City of Surrey  
**PLANNING & DEVELOPMENT REPORT**

Application No.: 7922-0223-00

Planning Report Date: April 17, 2023

## RESPONSE TO ADP COMMENTS

L101

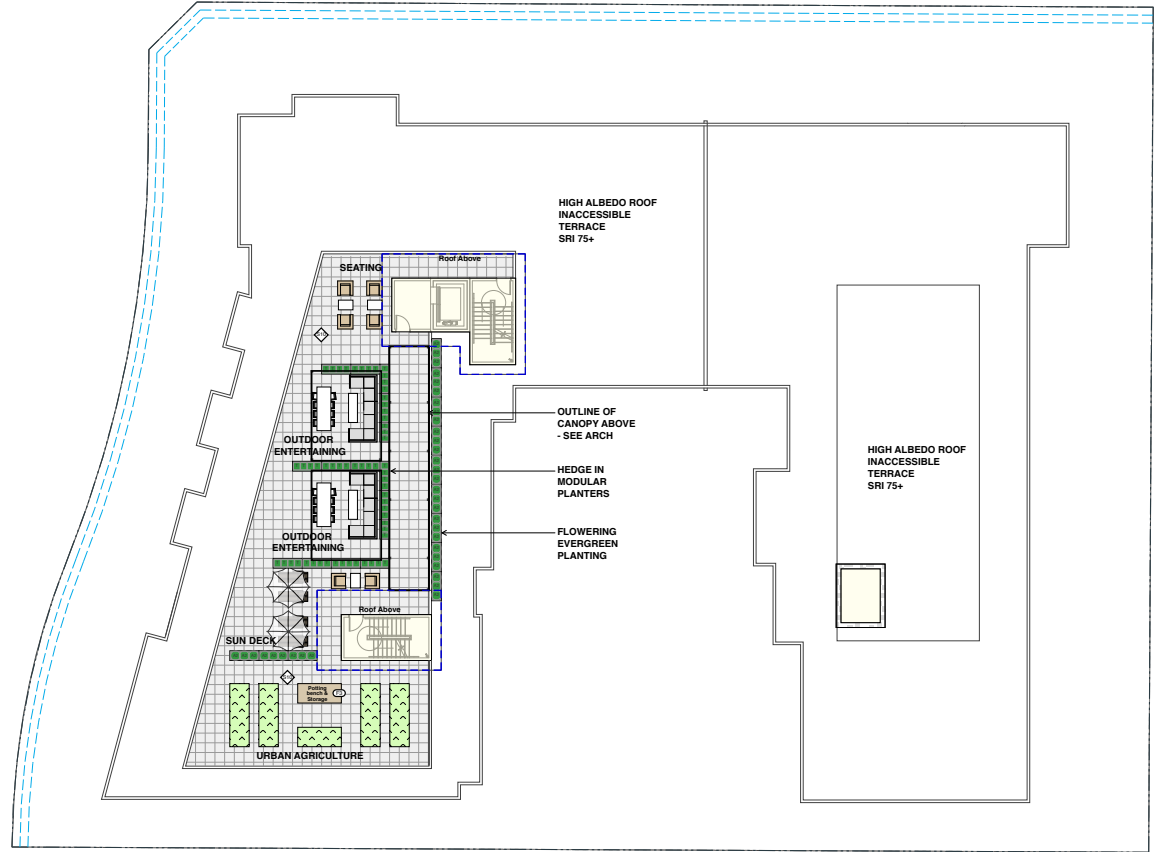
- Cross Section 1 and 4 – drawing L101; shows retaining wall between patio planting and street front planting. Recommend reviewing requirements for walls; deletion of wall will allow better availability of soil for yard trees. To achieve adequate soil depths over the structural slab, some retaining walls will be required. We have removed 3 walls along the street in front of 104a
